# The Falls

## 2 - Recommendation Meeting

### Design Review Staff Report

**Applicants:**  
Owner/Representative:  
Wes Southwick  
LB Stone Properties Group

SITE OVERVIEW

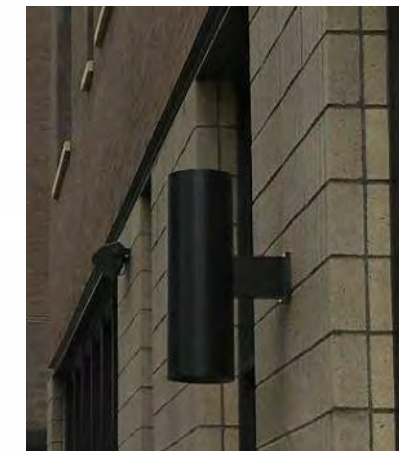
- 1. The applicant shall bring back before the board a detailed landscape and hardscape plan for the central plaza and the pedestrian pathway adjacent to the riparian habitat. This plan should include a placement plan for the proposed public art amenities.**

**RESPONSE:** See following pages for detailed landscape and hardscape plans for the central plaza and pedestrian pathway adjacent to riparian habitat. Public art locations have been added and identified. The plaza helps the project meet the comprehensive deisgn goals in the following ways;

LINCOLN STREET ENLARGED PLAN

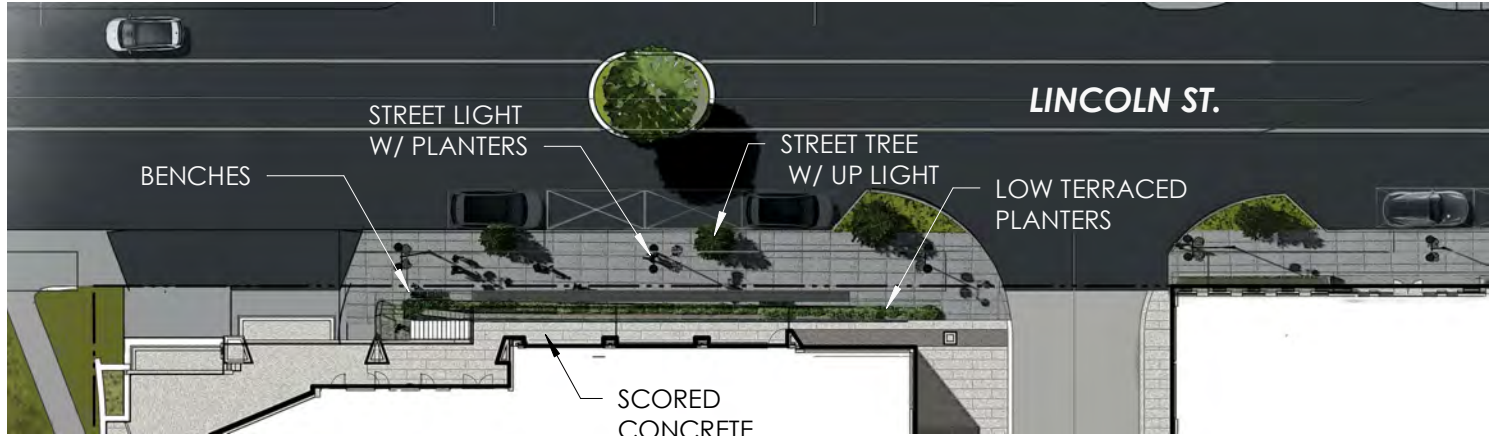
2. The applicant shall bring back before the board a detailed streetscape plan for the southwestern most frontage of Building 1 (fronting Lincoln Avenue), to include (but not limited to) a lowering of the proposed raised planter beds to improve the overall pedestrian experience.

See following pages for detailed landscape and hardscape plans for the Lincoln Street frontage. The Lincoln frontage has been revised and enhanced to meet the comprehensive design goals in the following ways:

- C-1** - Along Lincoln street we have lowered the terraced planter as recommended to make the street scape feel more pedestrian friendly and scale. We have also extended the planter and added natural plantings. There is a path and stair that accesses the retail and restaurant storefronts which is accessible from the street. Also refined was the lowering of the brick walls and replaced with Glass handrails.

EVENT PLAZA ENLARGED PLAN

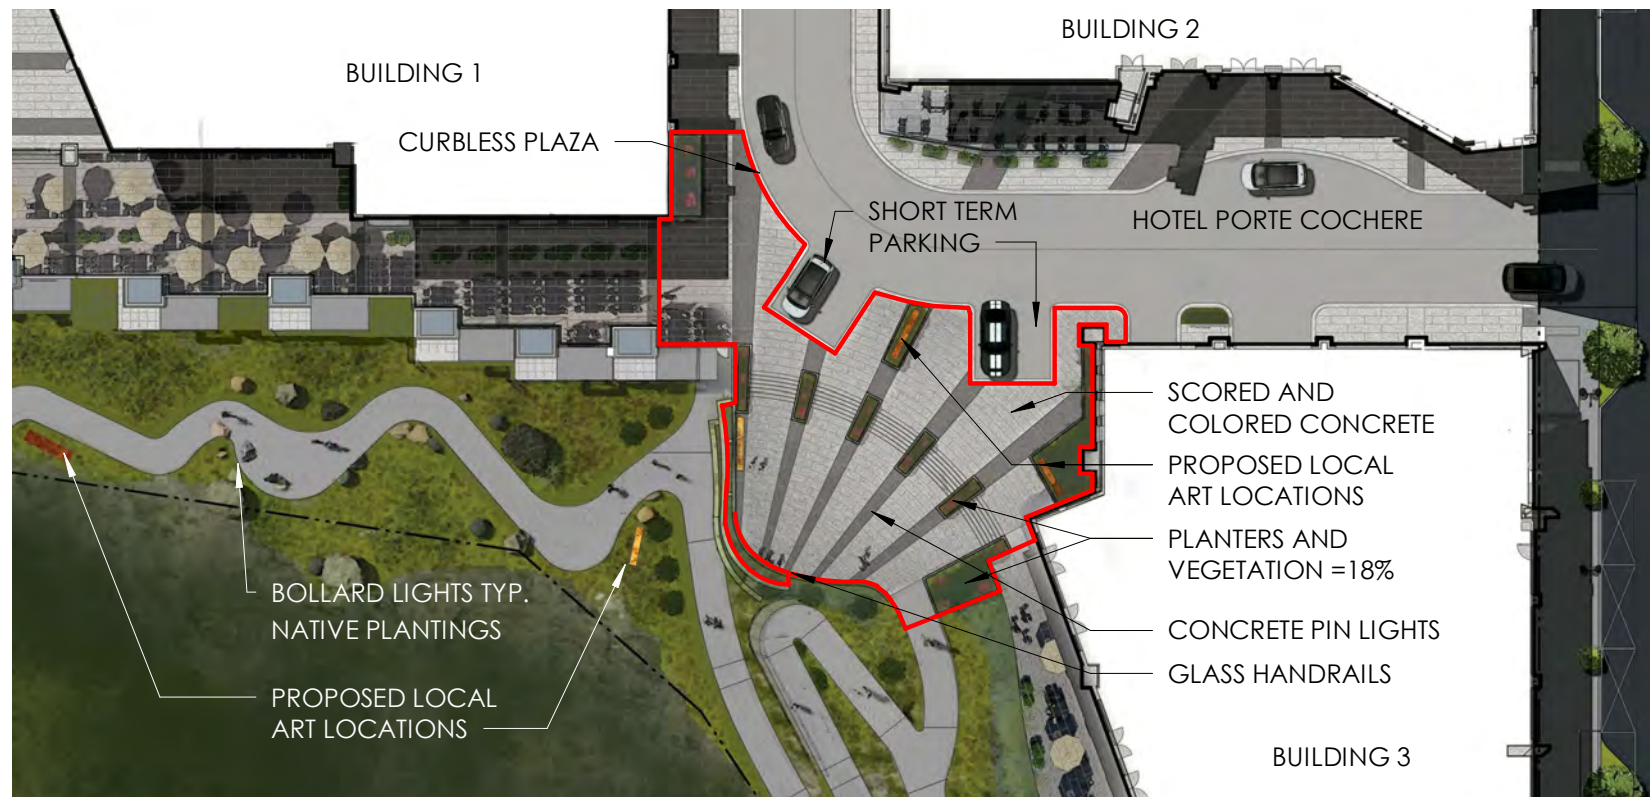
- Ensure that the correct percentage of landscaping is provided in the qualifying plaza area.  
**15% landscaping will be provided.**
- Minimal dimension of 10' (currently the qualifying plaza has a dimension near the parking stalls of only 7')

- Place appropriate bollards, lighting, or planters near proposed driveway parking stalls to limit vehicular encroachment onto pedestrian plaza area.

Landscape planters to be provided to limit vehicular encroachment into dedicated pedestrian space.
